711 HUNTER ST, NEWCASTLE

DEVELOPMENT APPLICATION RFI
DESIGN RESPONSE REPORT

19th of May 2023

PROPOSED STAGING GROUND FLOOR

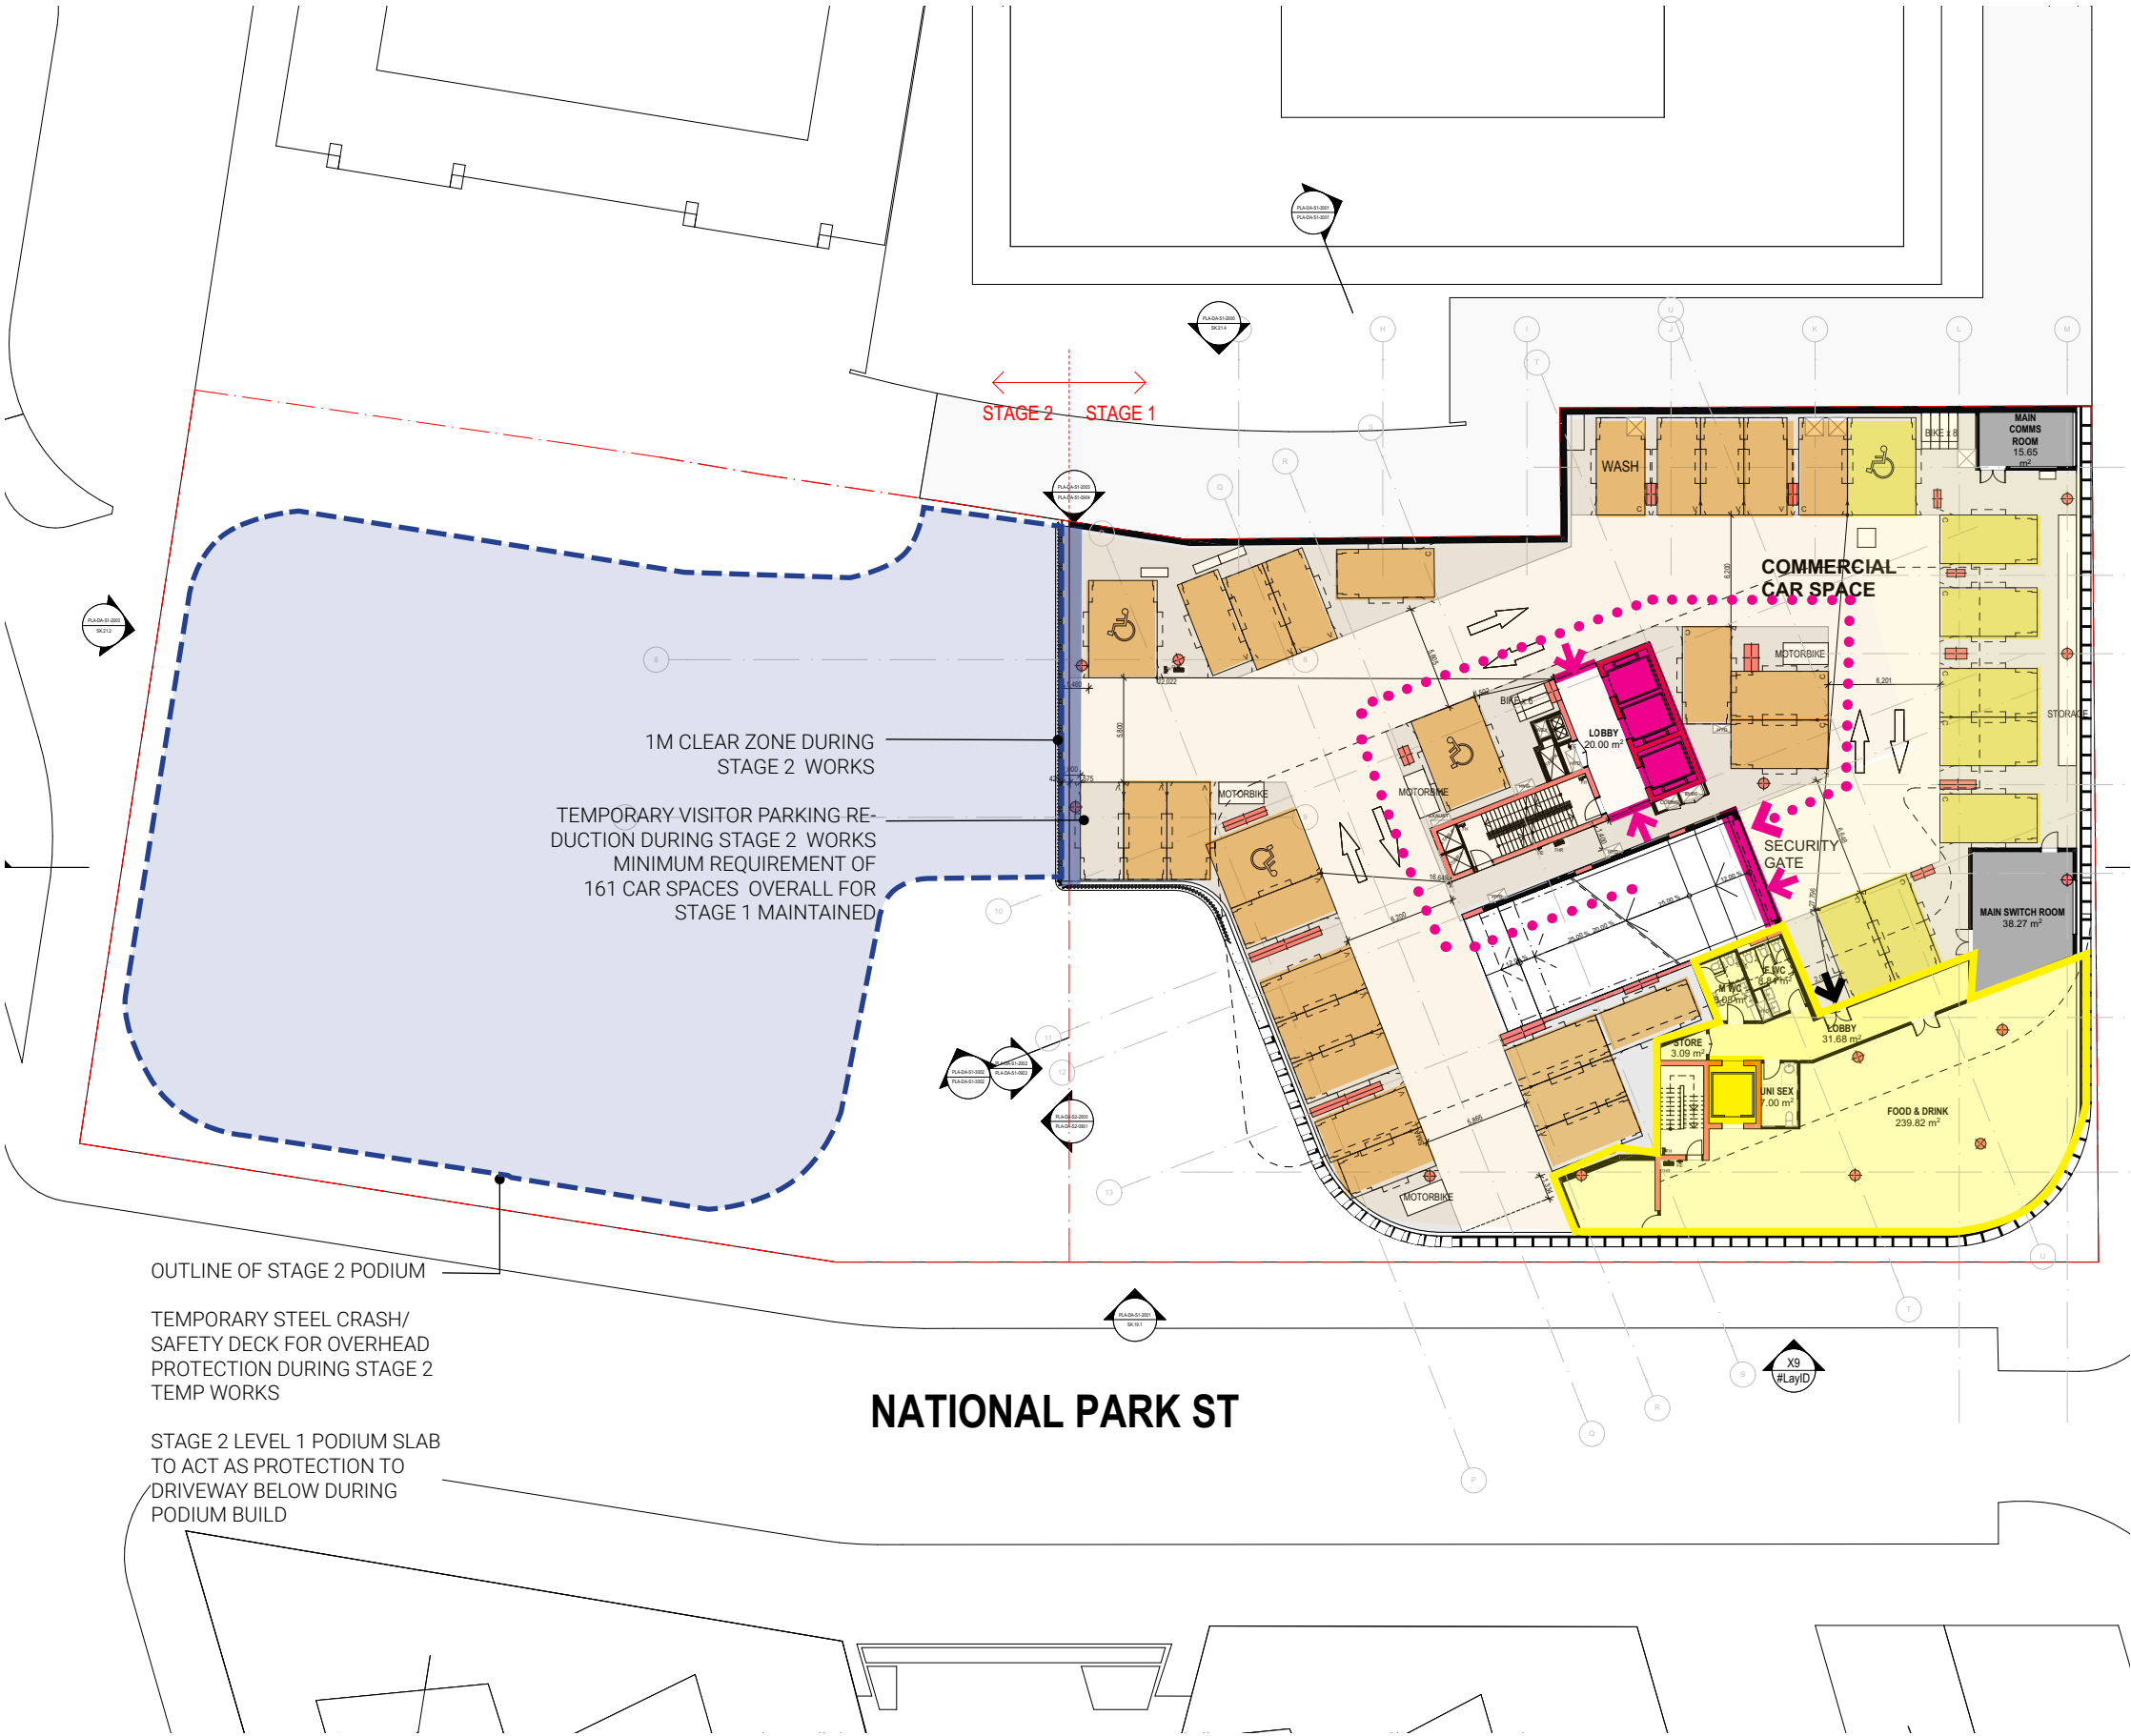
NO	RESPONSE	RESPONSE TO SUBMISSION	SUPPLEMENTARY MATERIAL
1	PROPOSED STAGING		
B	In the event the lower podium is constructed across two stages, as proposed, a detailed analysis being provided outlining the proposed strategy for construction of Stage 2. Further details are to be provided, which address the development will continue the operation of the driveway to Stage 1 whilst also maintaining public (resident) safety and minimising on-street congestion. This is to be presented in a comprehensive staged construction management plan.	Adequate vehicle and pedestrian pathways will be allocated during the construction of Stage 2. Safe operation of these access ways are outlined in the updated Construction Management Plan. Additional diagrams are provided in this report highlighting the access & operation of the car park during Stage 2 works	Refer to Proposed Staging page 16 Refer to amended CMP

C	Amended architectural plans to reflect the amended staging and must include a detailed landscape design for 'stage 2' land consistent with the connecting to country work undertaken to inform the overall design. The architectural plans for both stage 1 & 2 must demonstrate that stage 1 can operate independently of stage 2, including during construction works for stage 2 occurring.	Amended staging plans include a generous interim park in lieu of hoarding around the Stage 2 site. Stage 1 will also include a public art opportunity (mural) on the adjoining wall.	Refer to Proposed Staging pages 9-15 Refer to Landscape drawings prepared by Urbis Refer to Public Art Plan updated with interim Public Art opportunity for Staged approach.
E	An amended plan which clearly details any proposed drainage and associated easements (please ensure easement widths are correctly noted).	Amended architectural drawings include the location and extent of the flood storage on ground floor, rainwater tank and flood refuge on level 5. Water Management Strategy updated following meeting with Council engineers with a more detailed concept design showing stormwater management from Stage 2, through to discharge point on Hunter Street.	Refer to Engineering Matters pages 37 & 40 Refer to Draft Stratum plan updated with the inclusion of Stormwater easement details Refer to updated Stormwater Report, and Drainage Plan

At the ground plane, the proposed landscaped area provides a generous interim extension of the central open plaza at the heart of the development, while complimenting the surrounding parks and public areas.

During construction, various interventions are incorporated in the Construction Management Plan to address the safety and operation of Stage 1 occupants and visitors.

Stage 1 incorporates the necessary servicing and facilities to allow the commercial and residential components to operate without any reliance on Stage 2 works.

SEPARATION OF USES - STAGE 1 LEVEL 1

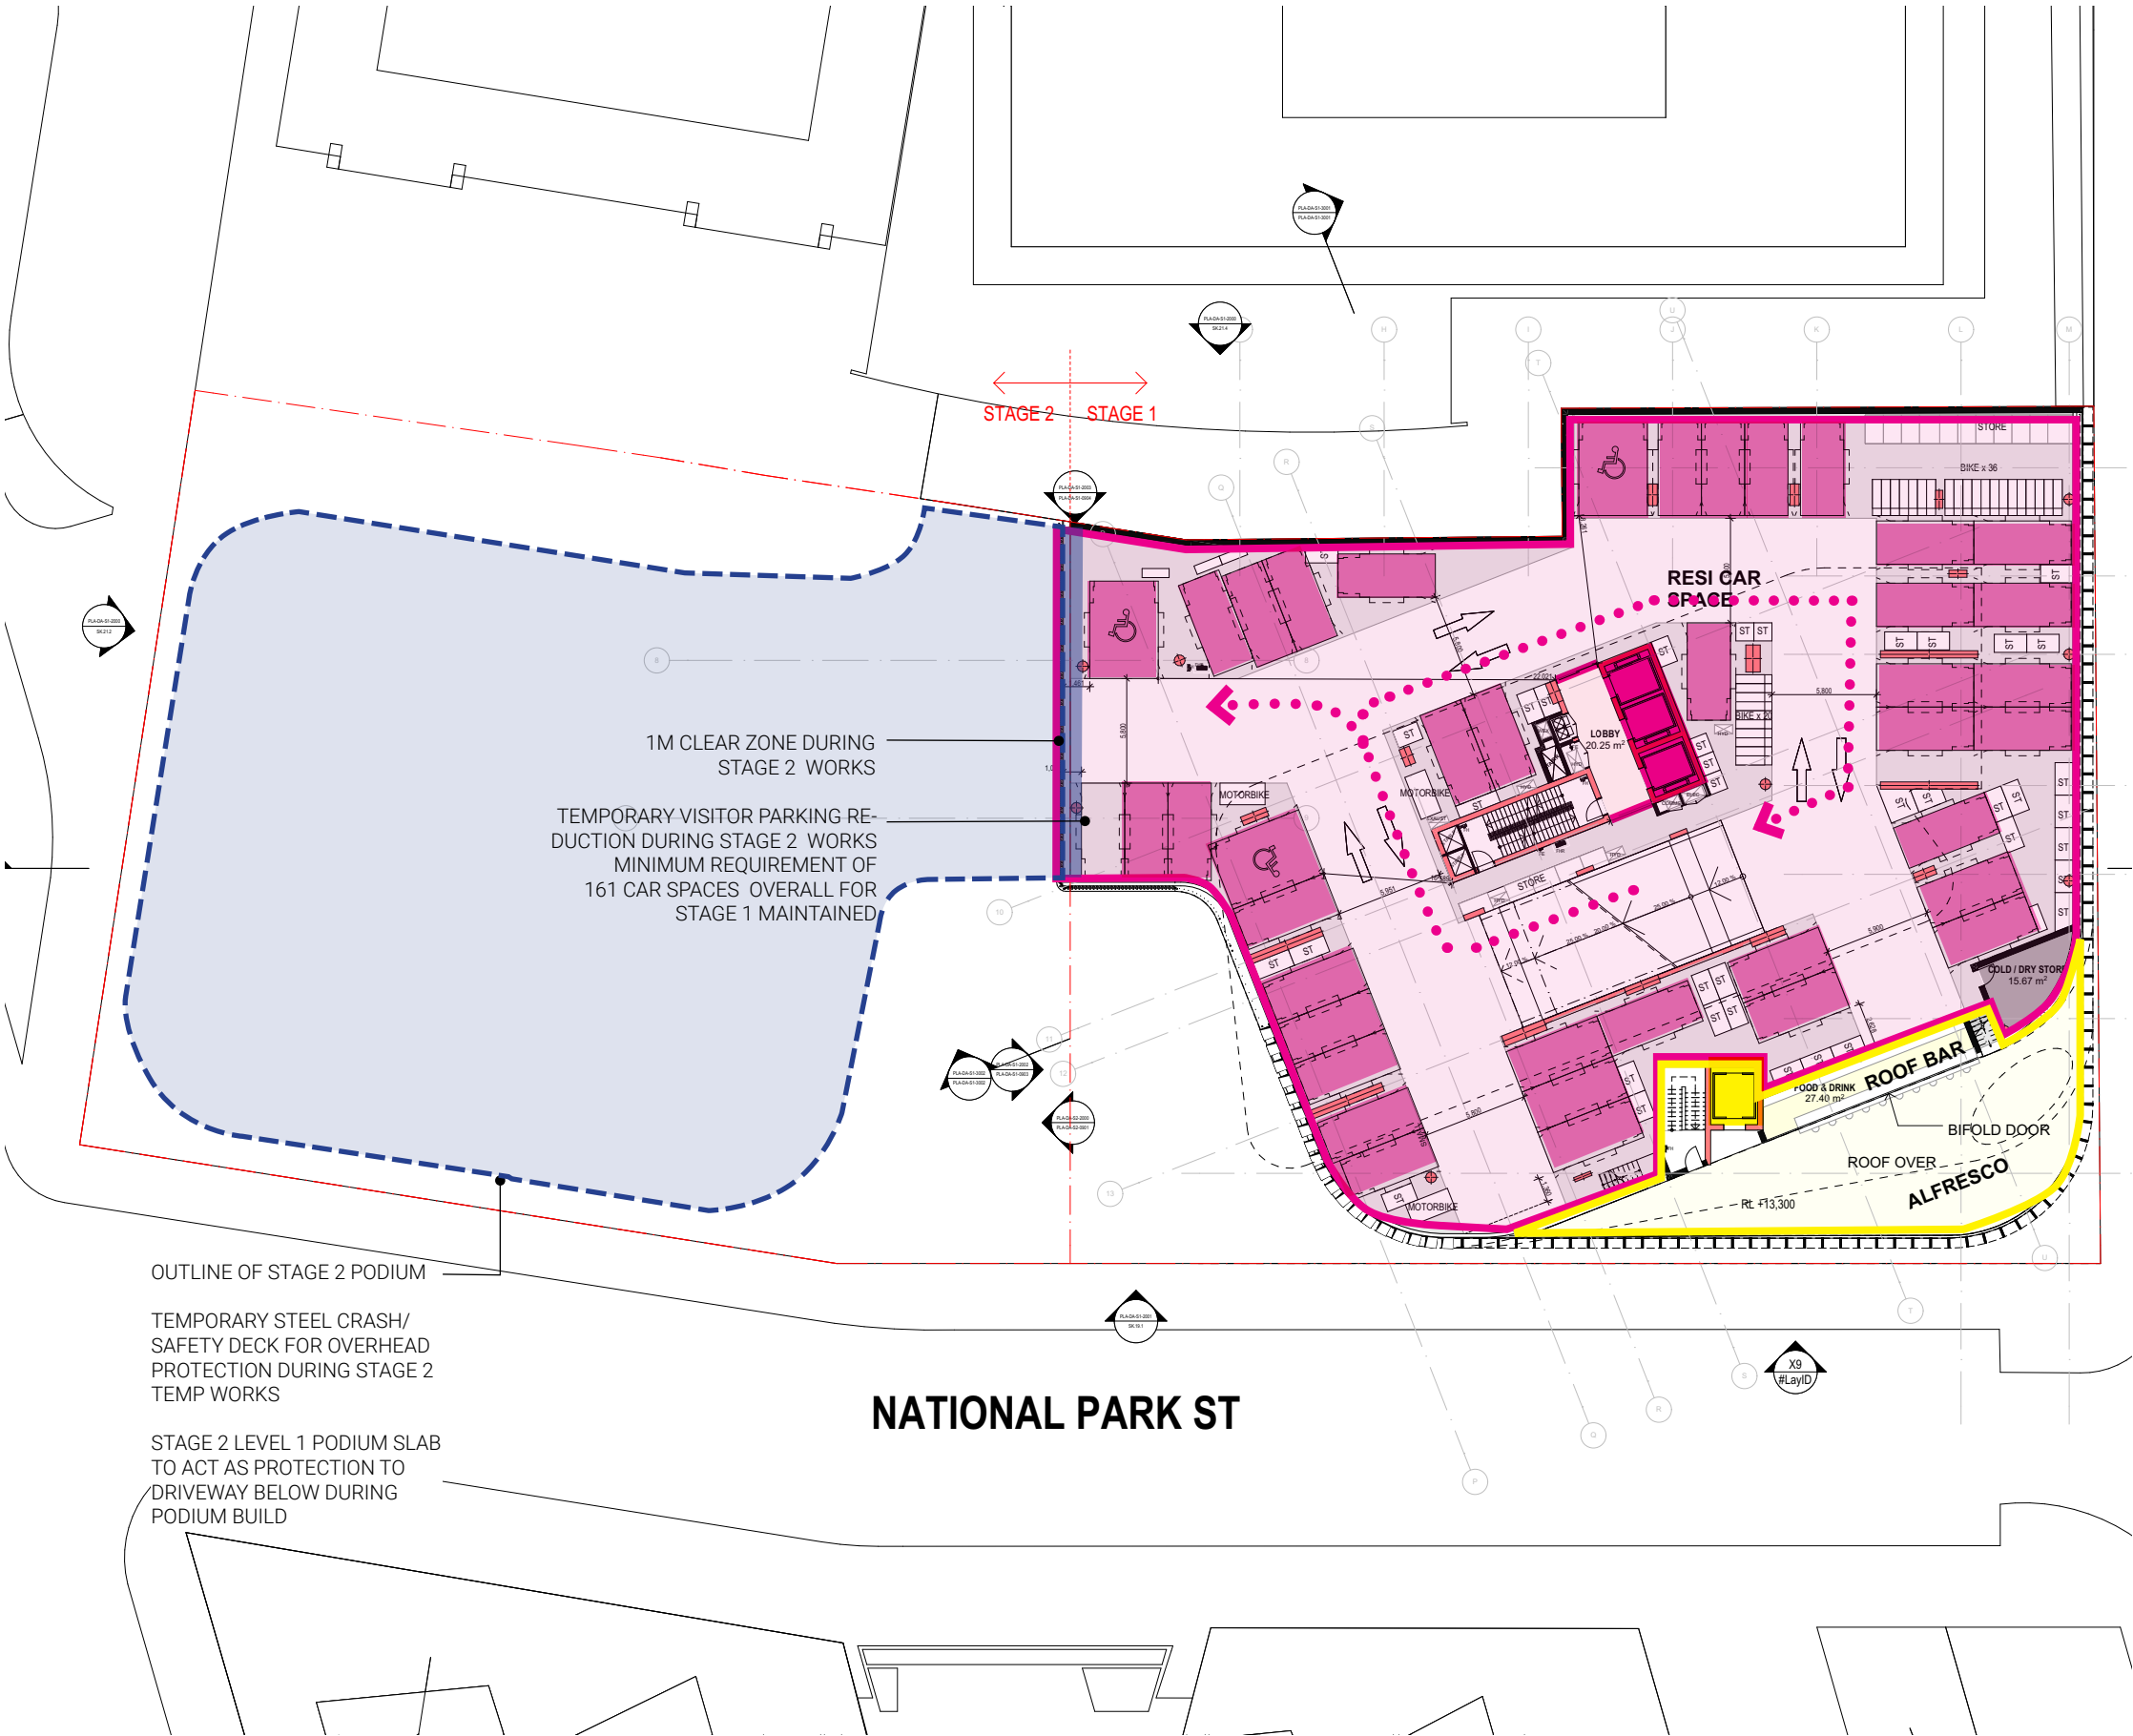
2	DESIGN EXCELLENCE, DIP / UDRP, and CPTED		
	...the amended plans must incorporate the recommendations of any specialist report supporting the application. For example, the submitted CPTED report makes numerous recommendations regarding the layout and operation of the proposal which have not been incorporated into the architectural plans (e.g., lobbies to each tower and separation of commercial and residential elements (including parking and storage cages).	The ground floor lobby entry for the northern tower is proposed to be relocated closer to the central area, as well as an additional window to its adjacent retail tenancy to improve its visibility from the street. Indicative street views are provided to illustrate how the combination of the ground plane, residential, retail frontages, as well as landscaping and lighting work together to create a highly activated ground plane. Commercial and residential parking and storage cages are separated via a security gate between levels 1 & upper levels. Diagrams are provided to illustrate that level 1 is a shared car parking space with designated areas for commercial that are separate to residential visitor car parking. All access to private residential areas are secured. All private residential storage have been relocated into the secured levels 2 and above.	Refer to CPTED Recommendations pages 24-26 Refer to amended CPTED report Refer to Proposed Staging pages 16-21, Refer to CPTED Recommendations pages 30-35 Refer to amended CPTED report

On Level 1, there are dedicated parking spaces for commercial and residential visitors only. Separate lobbies are provided for commercial and private residential areas, each serving their respective lift services.

To ensure security and separation between shared and private uses, a security gate is installed to separate private residential parking on the upper levels, while all private storage cages are also relocated to these upper levels.

GROUND FLOOR - PROPOSED AMENDMENT TO LOBBY ENTRY

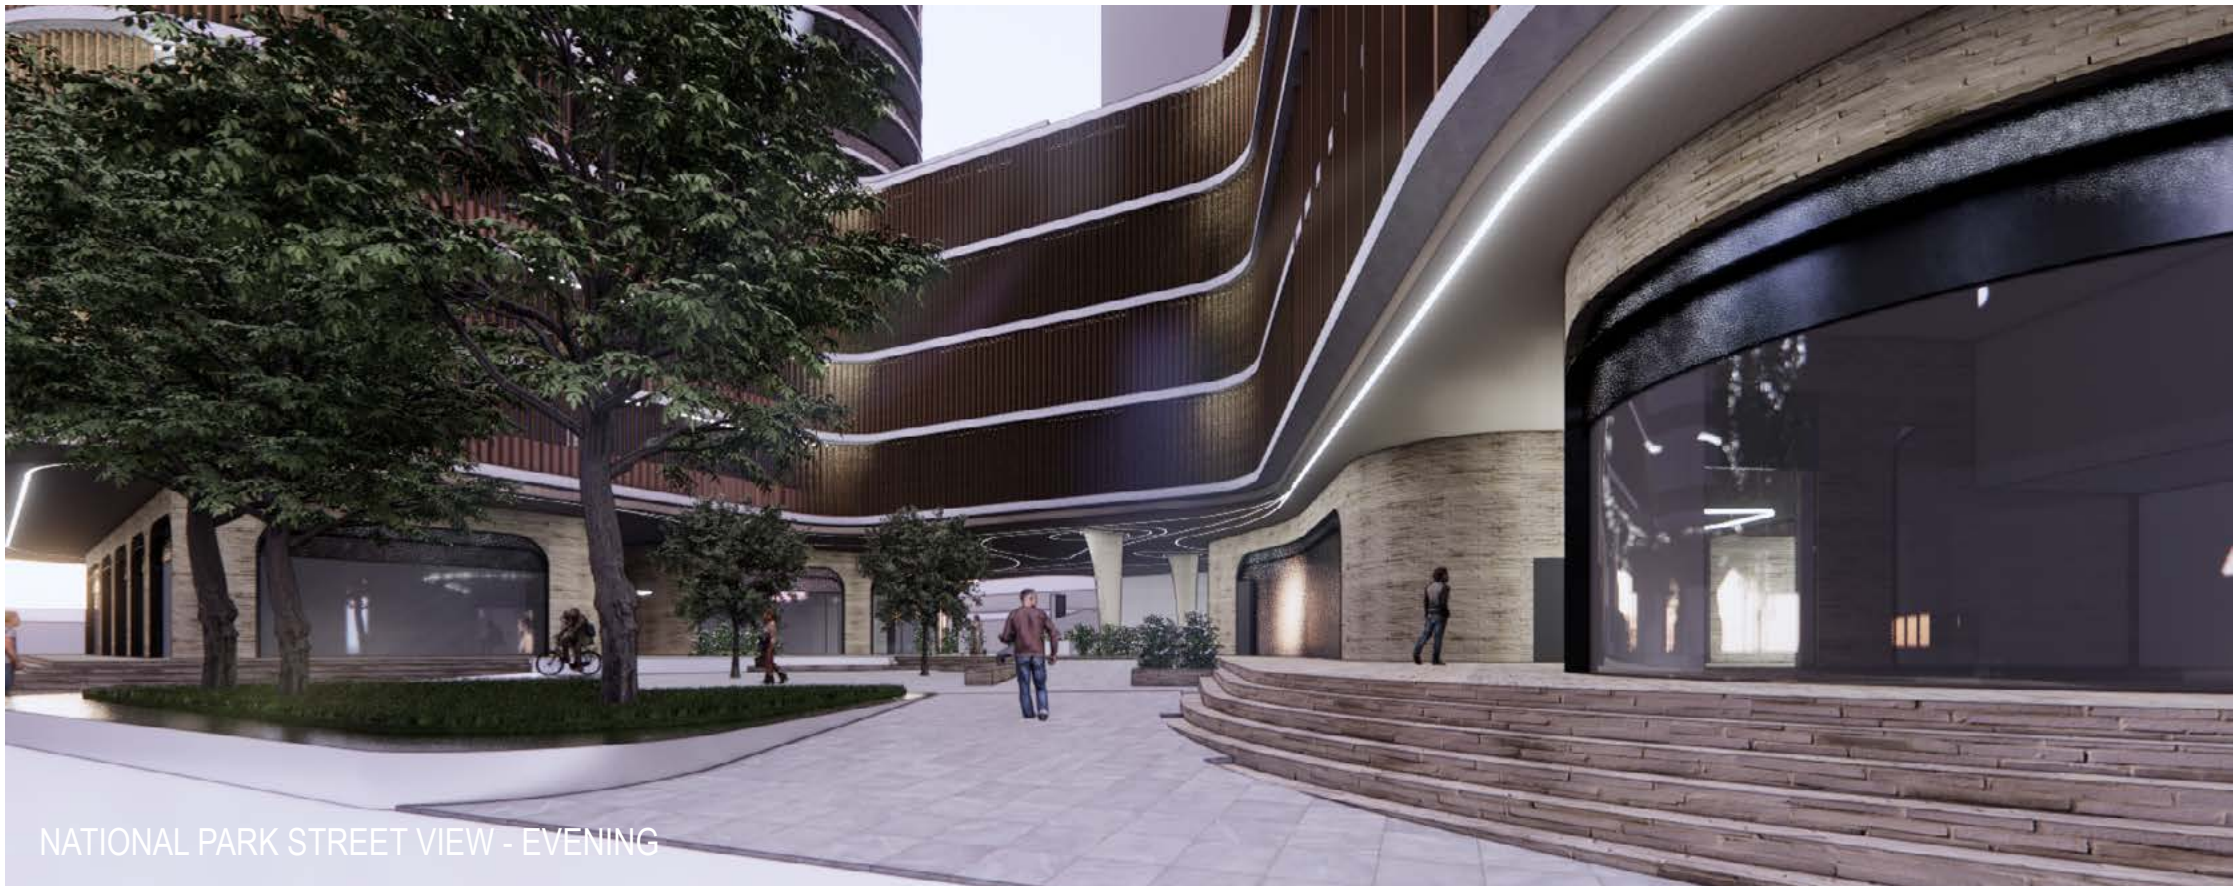
5	SAFETY		
	<p>The UDRP noted, and fully concurred with the concerns raised by the DIP in respect to the lack of CPTED consideration demonstrated in the layout of the residential pedestrian entrances at ground level. The proposed staging of the towers and the consequential partitioning of the landscaped communal space between them, has potential to further exacerbate the condition that the DIP raised concerns about in respect to CPTED. Both the design for the eventual completed central space, and especially the reduced area available in stage one, need to be further considered in respect to providing safe and welcoming all-hour access to residential lobby spaces.</p> <p>The Panel noted the modified car park layout for Stage 2, Levels 01 and 02, spaces Residential R.050, 051 and R.121, 122 appear to conflict with the pedestrian open corridor and does not provide a safe swept path due to the corridor’s skewed geometry.</p>	<p>Amended staging plans include an interim landscaped park and additional public art opportunity to enhance the communal ground plane for Stage 1. The northern tower’s ground floor lobby entry is proposed to be relocated closer to the central area, with an additional retail window to improve visibility and security of the entrances. These adjustments along with the proposed landscape and lighting strategy address concerns raised by the DIP regarding the lack of CPTED consideration in the layout of residential pedestrian entrances at ground level and ensure safe and welcoming access to residential lobby spaces at all hours</p> <p>Dimensions shown to all car parking aisles on architectural drawings.</p>	<p>Refer to Proposed Staging pages 9-15 Refer to CPTED Recommendations page 24-26</p> <p>Refer to Engineering Matters page 39</p>

Together with a well-designed landscaping scheme and open space, this can help to improve the security of residents and visitors while providing an attractive and vibrant public area.
